**WALLACE J. TOSCANO A.I.A.
ARCHITECT**

RE: Weinhoff Residence
3 Maple Way
Armonk NY 10504

CAMPBELL ENGINEERING PC

The following are our responses to your memo updated to March 24, 2023. The responses are numbered the same as the comments in your memo.

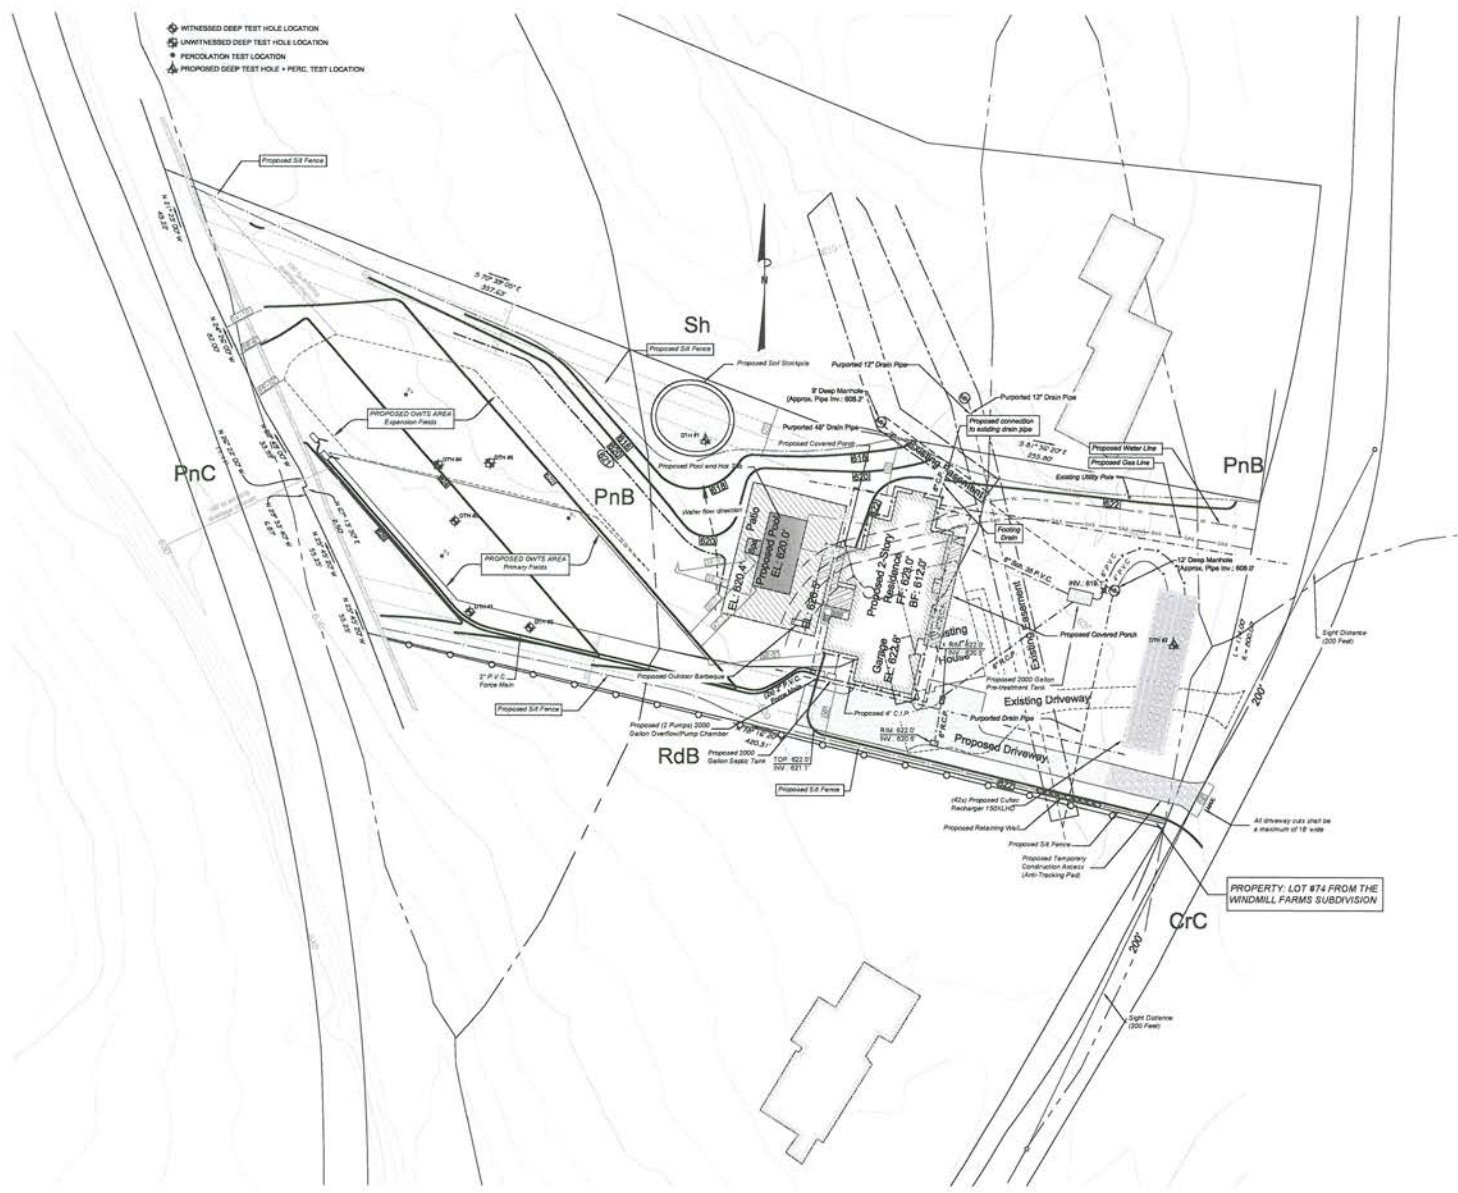
7. A construction detail or procedure is in the SWPPP.
8. Sheet S-3 indicates the existing conditions. We are removing all structure on the site.
9. The architect for the proposed house is preparing the detail for the proposed Belgium block. They will provide the required information to the Town.
